**FINAL
ENVIRONMENTAL STATEMENT**

**NORTHERN POWDER
RIVER BASIN COAL,
MONTANA**

FINAL
ENVIRONMENTAL STATEMENT
REGIONAL ANALYSIS

C. COMMENT LETTERS AND RESPONSES

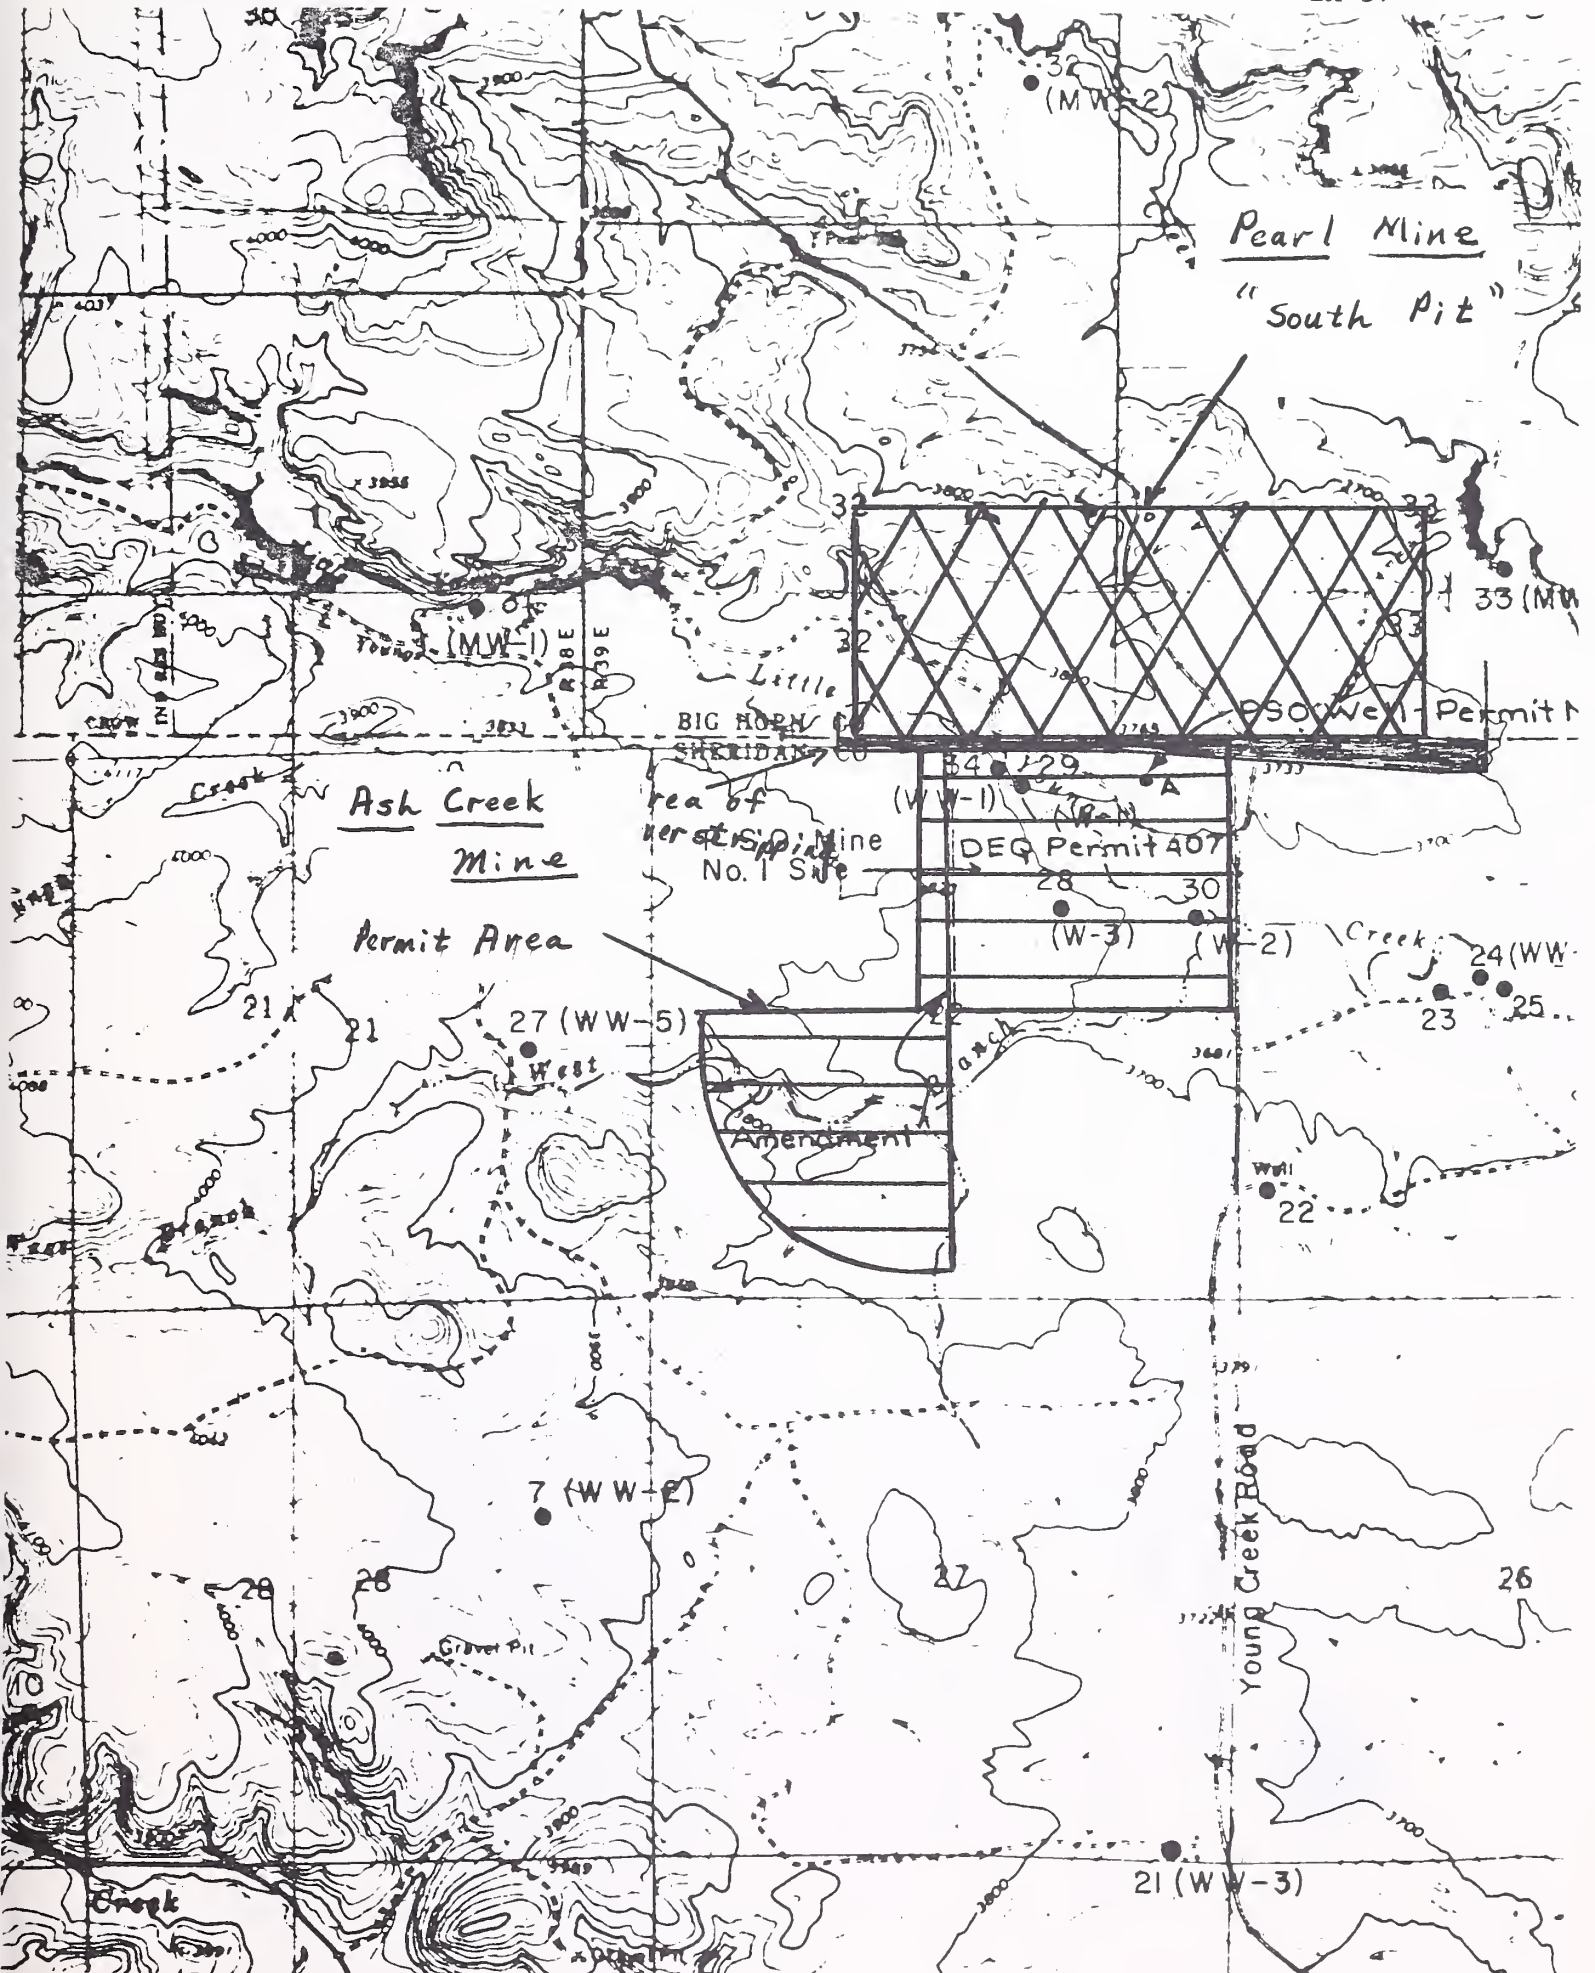
The "old county road", as shown on Figure I-7, is improperly shown in the southeast portion of the figure. The existing road runs along the section lines of sections 22 and 23.

The proposed "relocated county road" would diagonally cross crop and hay-lands associated with the Little Youngs Creek drainage, (Section 23) disrupting the use of these lands for intensive agricultural purposes. Alternative routes should be investigated.
